Structural Paper No. 53

Masonry arch bridges: a study †

Discussion

Fig. 32

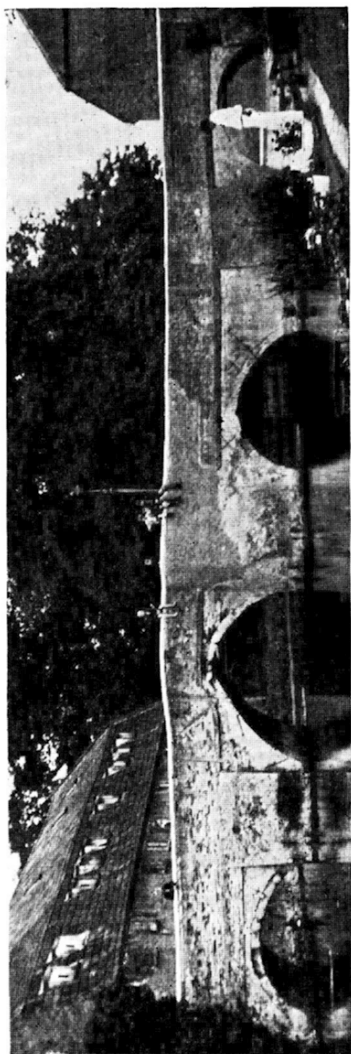
Mr P. C. Dewhurst (retired) called attention to the very remarkable case of a bridge-arch, which, although completely disrupted, continued in effective use. The bridge, mostly of brick with stone arch-rings, had spanned the River Little Ouse at Brandon in Suffolk, but it no longer existed.

232. Fig. 32 showed how in one of the arches, which had split completely from side to side near the crown, the two surfaces of the separated portions had ridden one over the other in a fantastic manner. In that condition the arch—and bridge—had continued for many years to carry normal heavy main-road loads, forming an integral part of a trunk route. It had finally collapsed under excessively heavy war-time vehicles between 1939 and 1945.

233. The bridge had been built in the dry on piles, the river being afterwards diverted to flow under it. Its massive piers can be seen in Fig. 32, which also shows that other portions of the bridge, apart from the defective arch, had been rebuilt or patched from time to time. The bridge was severely cranked in plan and from above appeared rather like a series of single arches not laid out in line.

234. What was the Authors' opinion as to the possible sequence of events connected with the fracture—the middle pier seemed to have moved bodily towards the warehouse—and how the arch had managed to support heavy main-road traffic for so many years?

244. Mr Dewhurst had drawn attention to what he rightly called the very remarkable case of the old Brandon Bridge, now replaced by a modern structure. It was indeed surprising that the main arch had carried the traffic of a Class I main road for many years though seriously deformed. This deformation, which occurred in the extreme form shown in the illustration on the west side of the arch only, appeared to have been caused by the left pier tilting transversely because of unequal settlement at its two ends. The arch crown, though broken at the west side, was held up, partly at least, by an iron clamp across the break which brought the strength of the parapet into play. Also, of course, the half of the centre part on the right of the illustration would abut on the fill opposite, so that, in this particular case, the fill could be said to be acting as a structural material.
